A66 Northern Trans-Pennine project

TR010062

7.9 Applicant's Comments on Local Impact Report

Deadline 2

Figure 1: Average speed between M6 J40 to Single/Dual Transition east of Kemplay Bank - Monday to Friday

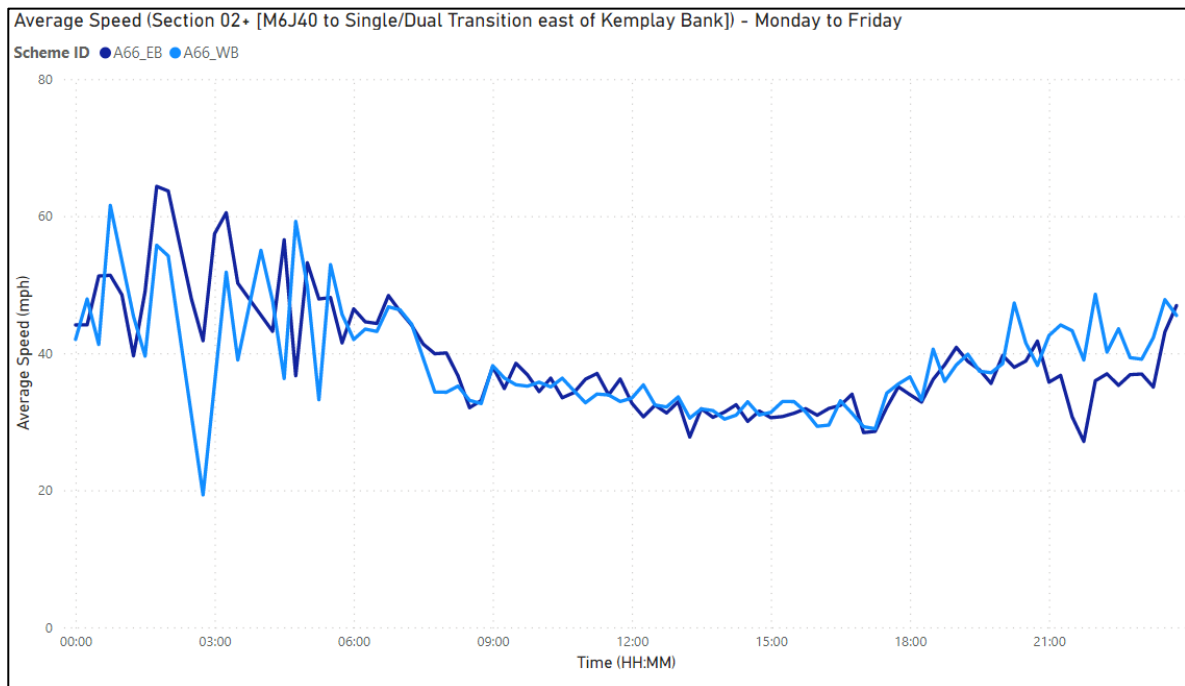
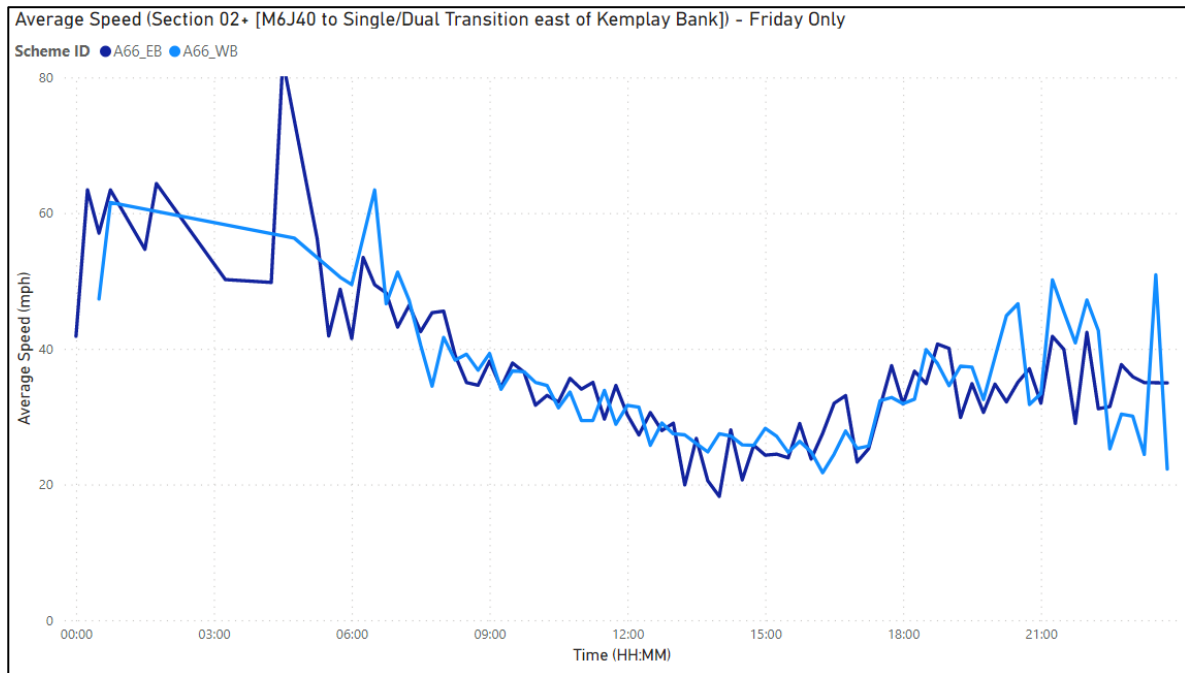
2.3.30. Paragraphs 2.4.8 – 2.4.19 and Figure 2-11 to 2-13 of the Transport Assessment (Document Reference 3.7, APP-236) provide commentary on observed speeds along different sections of the A66 route. The section between M6 J40 and Kemplay Bank is covered by Scheme ID

2.3.31. Figure 1 displays the average speeds experienced throughout the day Monday – Friday, with Figure 2 displaying the data for Friday only. This is the same data used to produce the scheme 02+ data in Figure 2-11 and Figure 2-12 from the Transport Assessment (Document Reference 3.7, APP-236) respectively, displayed as an average throughout the day rather than a daily average per month. They demonstrate that although speeds reduce during the congested periods previously discussed, speeds are well below the posted speed limit (70mph) throughout the entire day. This continuity of reduced average speed (as compared to the posted speed) is a result of Kemplay Bank being only 1km away from M6 J40. Grade separation of Kemplay Bank removes this physical restriction, as well as providing significant additional capacity to the junction itself by removing A66 through-traffic. The increase in lanes from 2 to 3 in both directions between M6 J40 and Kemplay Bank also provides additional capacity to the network.

2.3.32. When considered in terms of journey time, the extent of the dual carriageway from M6 J40 to the point east of Kemplay Bank (where it returns to single carriageway) is approximately 3.5km. Table 2 details the equivalent journey time if a vehicle were to travel at different average speeds. The difference in journey time between the highest average speed experienced daytime (07:00-19:00) of approximately 40mph and the lowest of approximately 20mph is approximately 3 minutes.
